Re: Paric Corporation Project No. 15051
15051-Webster University Interdisciplinary Science Building
CP-054 - RFI 327 - wrap fireproofing at mechanical shaft

REQUEST FOR INFORMATION **DATE:** October 17, 2016 **NO.:** RFI-327

Subject: Fireproofing at Level 0 shaft

FIREPROOFING
SHOWN IN AIR
VENT

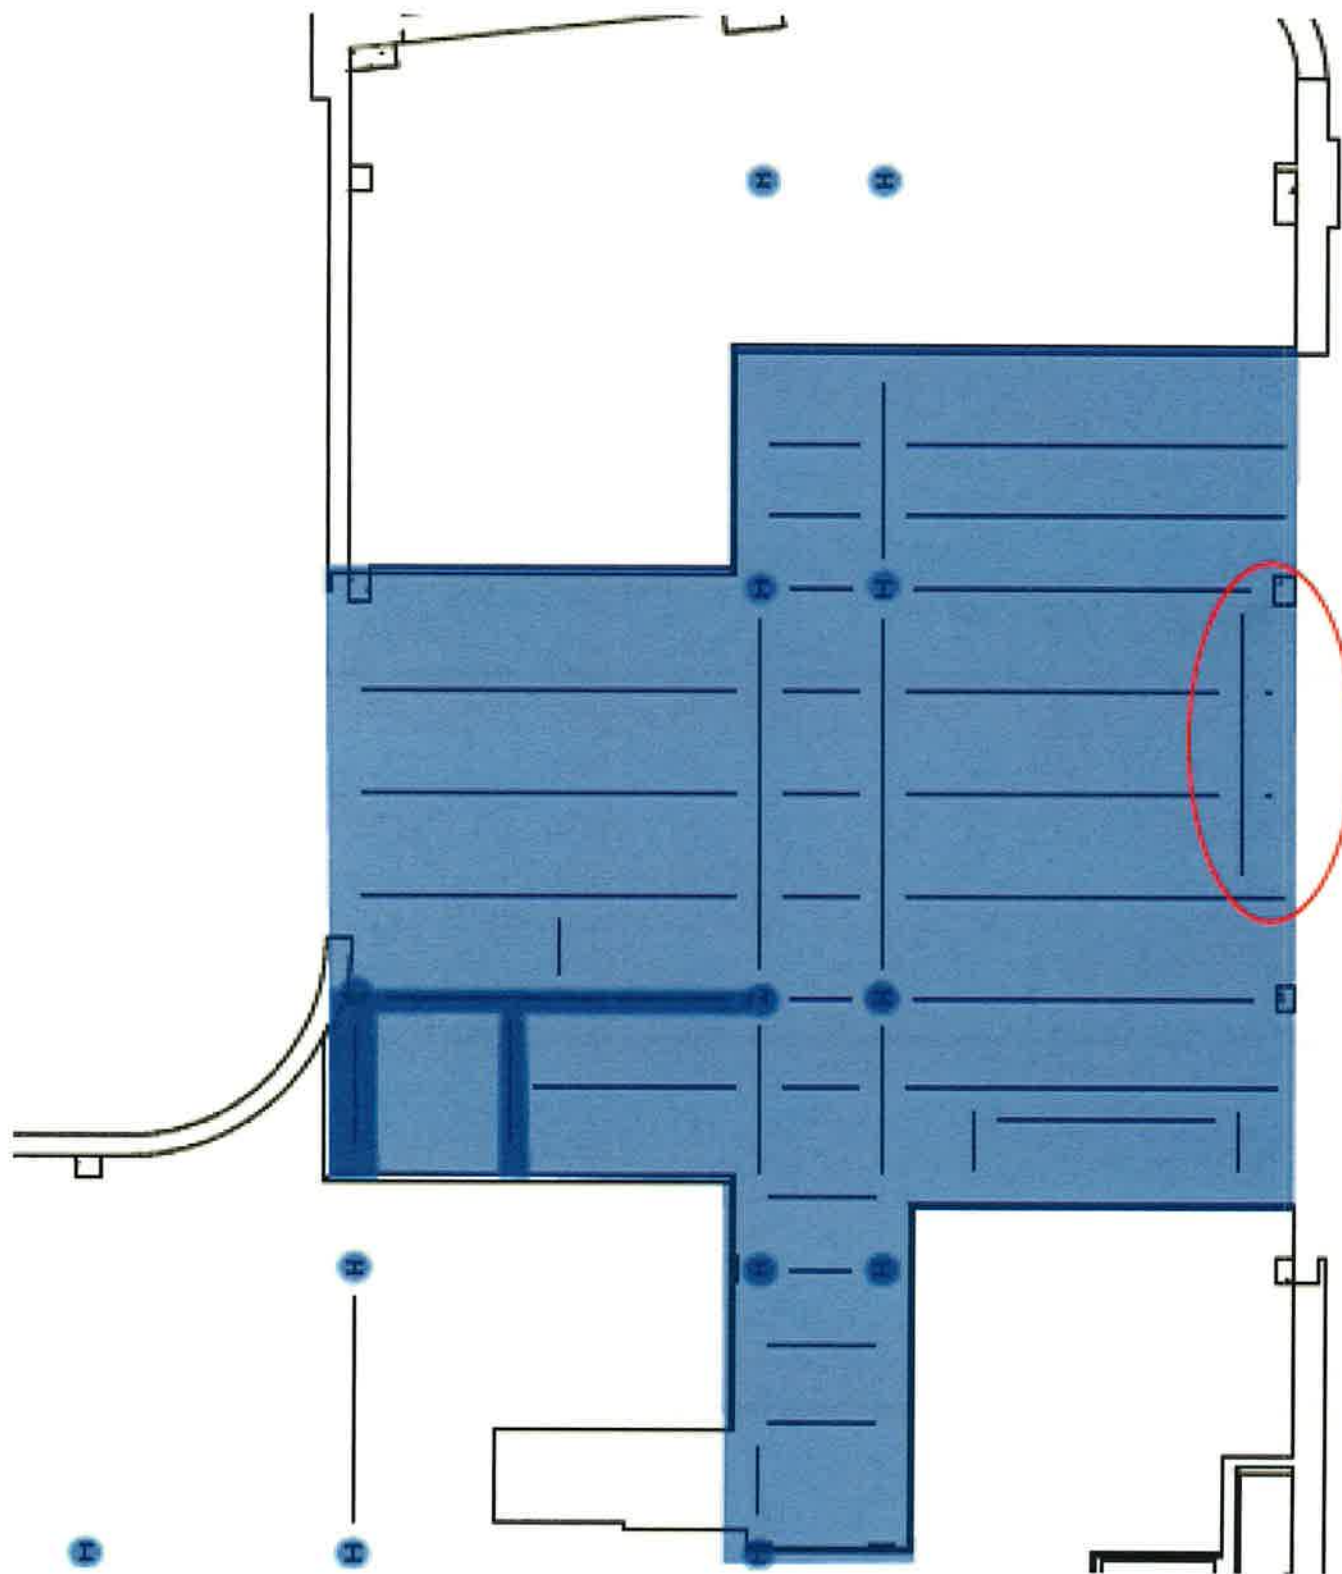
2/G0301 shows fireproofing in the area to be used as a vent for the mechanical systems. This would end up with fireproofing material in the air flow.

Suggestion: Paric proposes to fireproof as shown but cover the inside of the beams with a sealed sheet metal solution. Please advise if this is acceptable and provide a sketch if needed.

**Yes, sheet metal sleeves between fireproofed structure is acceptable as long as the opening for airflow is as large as possible (57 sq. ft. was the minimum size we accepted).
Please advise if a sketch is required.**
